Well Name: HENRY AGC FEDERAL	Well Location: T23N / R7W / SEC 29 / NWNW / 36.202824 / -107.604546	County or Parish/State: SANDOVAL / NM
Well Number: 1	Type of Well: OIL WELL	Allottee or Tribe Name:
Lease Number: NMNM36943	Unit or CA Name:	Unit or CA Number:
US Well Number: 300432083200S1	Well Status: Producing Oil Well	Operator: DUGAN PRODUCTION CORPORATION

Type of Submission: Notice of Intent

Type of Action: Plug and Abandonment

Attachment to notice of Intention to Abandon

Current Wellbore Schematic

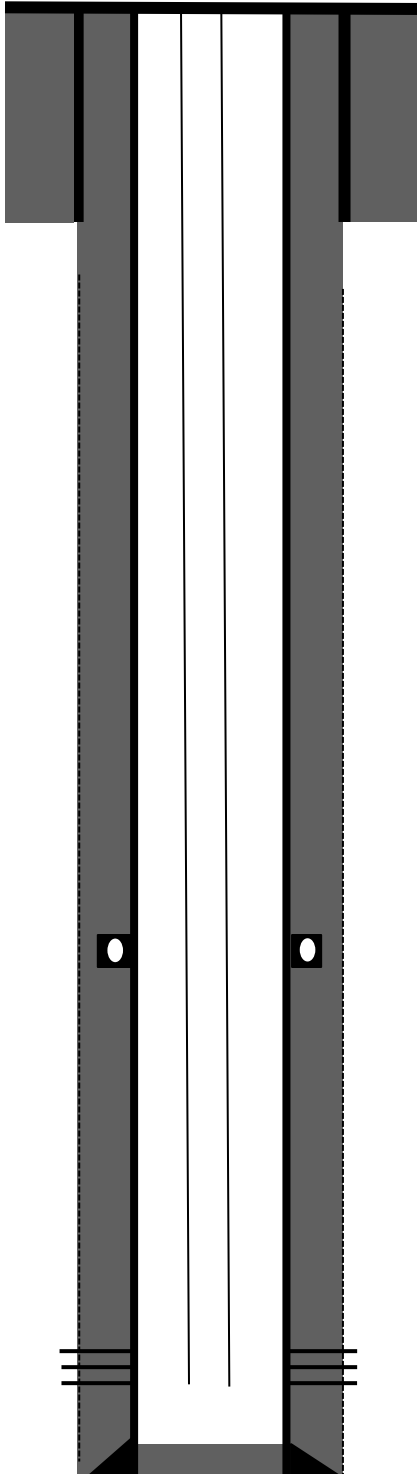
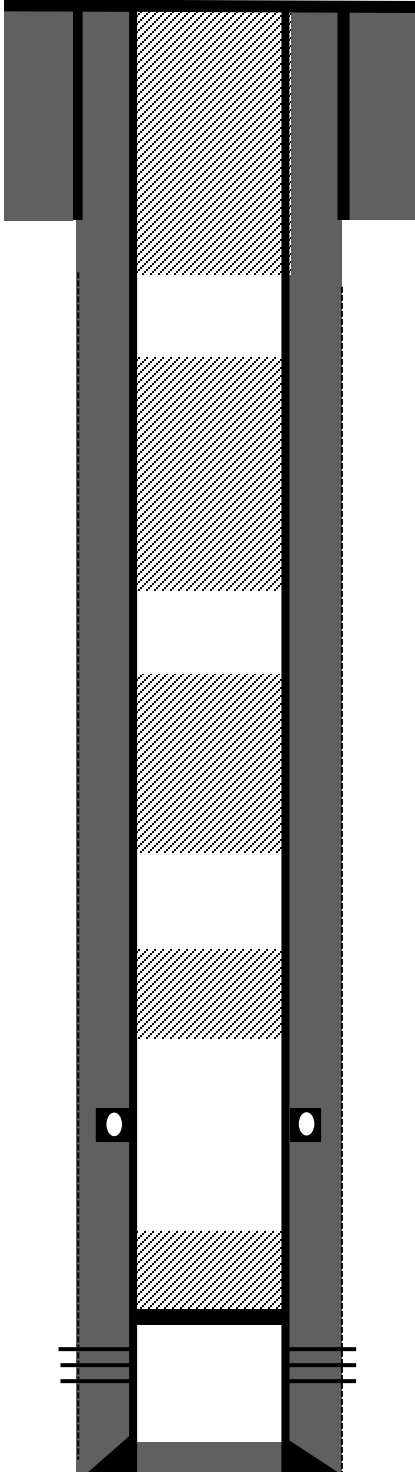
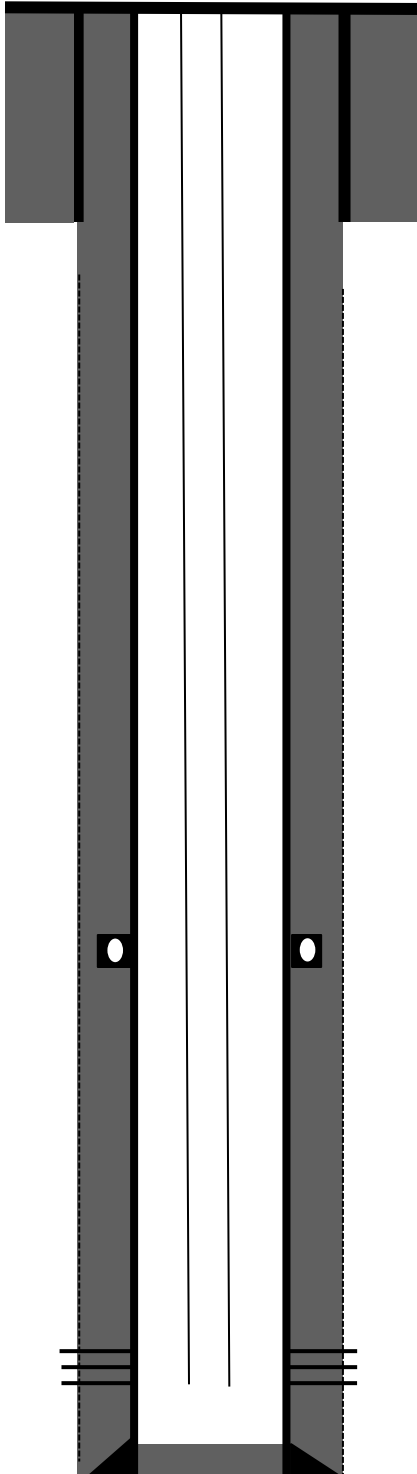
-Plug 2 must be moved to cover 3980' - 4130' because of the BLM top and 50' required excess.

-There is a significant difference between the Operator's and the BLM Geologist's picks for the Mesa Verde and Chacra tops. This results in a longer Plug 3: 3070' - 2232'.

- Plug 4 must be moved to cover 825' - 1600' because of the BLM top and 50' required excess.

1. Plugging operations authorized are subject to the attached "General Requirements for Permanent Abandonment of Wells on Federal and Indian Lease."
2. Farmington Office is to be notified at least 24 hours before the plugging operations commence at (505) 564-7750.
3. The following modifications to your plugging program are to be made:
 - a) Plug 2: Must be moved to 4130 feet to 3980 feet to cover the BLM pick for the Manco Shale top with 50 feet excess.
 - b) Plug 3: Significant differences between the Operator's and the BLM Geologist's picks for the Mesa Verde and Chacra tops. Because of this adjust Plug 3 to cover the interval from 3070 feet to 2232 feet.
 - c) Plug 4: Must be moved to 825 feet to 1600 feet to cover the BLM picks for the Pictures Cliffs, Fruitland Formation, Kirtland Formation, and Ojo Alamo Sandstone with 50 feet excess.

You are also required to place cement excesses per 4.2 and 4.4 of the attached General Requirements.
